Sydney Grammar School

Access Design Assessment Report  
Schematic Design

Weigall Sports Complex  
SSDA 10421

Project: Weigall Sports Complex  
Document Type: Access Design Assessment Report  
Our Reference: P220\_051-2 (ACCESS) LB

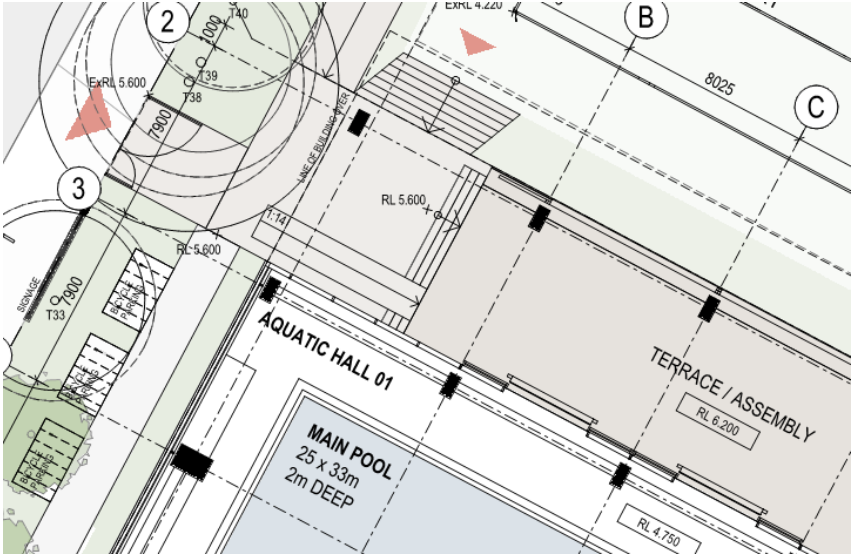
DESCRIPTION	COMMENT	RESOLUTION
Pedestrian entries	The main pedestrian point of entry will be from Nield Avenue.  A preliminary review has revealed the entries are capable of complying, however landscaping plans would be required to confirm	Landscaping plans to be provided for assessment.

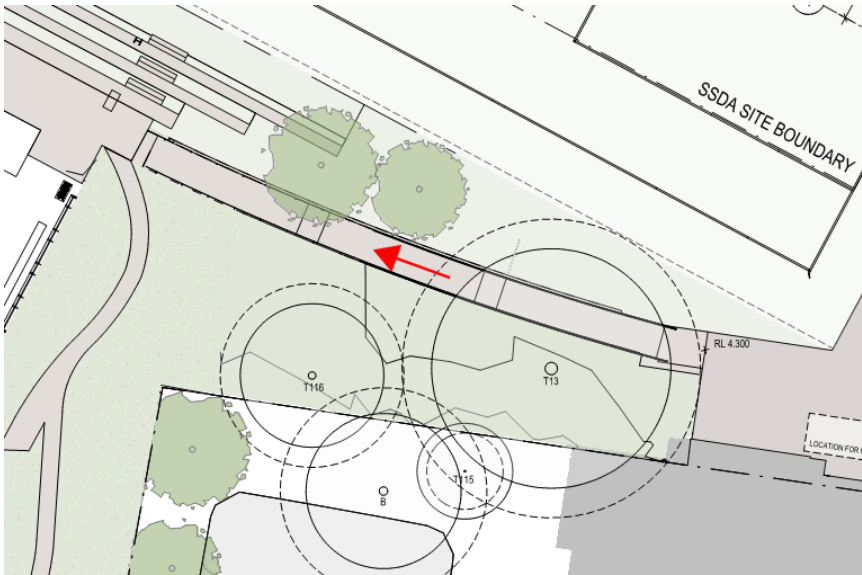
DESCRIPTION	COMMENT	RESOLUTION
	 <p data-bbox="724 824 1062 857"><b>Figure 1 - Pedestrian entry</b></p>	
<p data-bbox="225 898 357 1059">Pathway from carpark to sporting complex</p>	<p data-bbox="403 898 853 965">A second pedestrian entry being from the separate carpark.</p> <p data-bbox="403 976 882 1171">A preliminary review has revealed the entries are capable of complying, however detailed landscaping plans would be detailed during design development.</p>	<p data-bbox="911 898 1385 965">Landscaping plans to be provided for assessment.</p>
	 <p data-bbox="683 1771 1106 1805"><b>Figure 2 – Pathway from carpark</b></p>
